TRIMMER ATTACHMENT TA850  
(537353501, 537353502)

# Illustrated Parts List - IPL Update

**TA850**

**A** TA850  
ATTACHMENTS

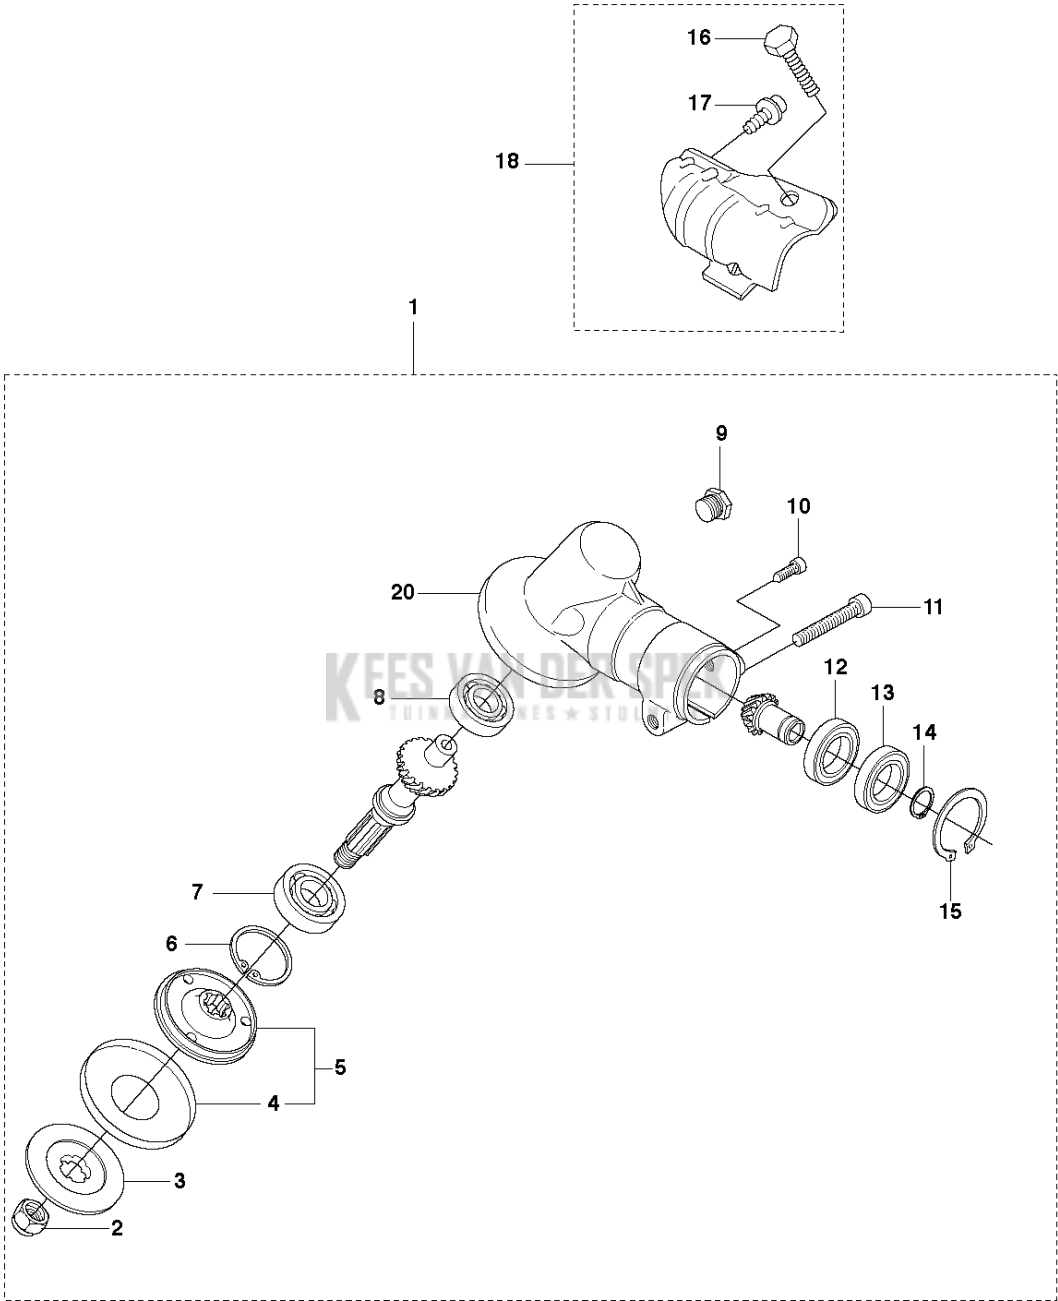
New tube assy, with updated plug, drive shaft and a clip, for an easier assembly (Click-on function)

Drive shaft 587 41 17-01 and plug 587 41 46-01 are backward compatible.  
NOTE: Clip 583 93 83-01 does not fit with plug 544 37 87-01 and drive shaft 537 01 19-01.

<b>Page title</b>	<b>Ref. no</b>	<b>New part no</b>	<b>Name</b>	<b>Excl. part no.</b>	<b>Remark</b>
Attachments	7	587 98 81-01	Tube assy	537 07 99-02	
Attachments	10	587 41 46-01	Plug	544 37 87-01	
Attachments	12	587 41 17-01	Drive shaft	537 01 19-01	
Attachments	14	583 93 83-01	Clip		<b>New part</b>
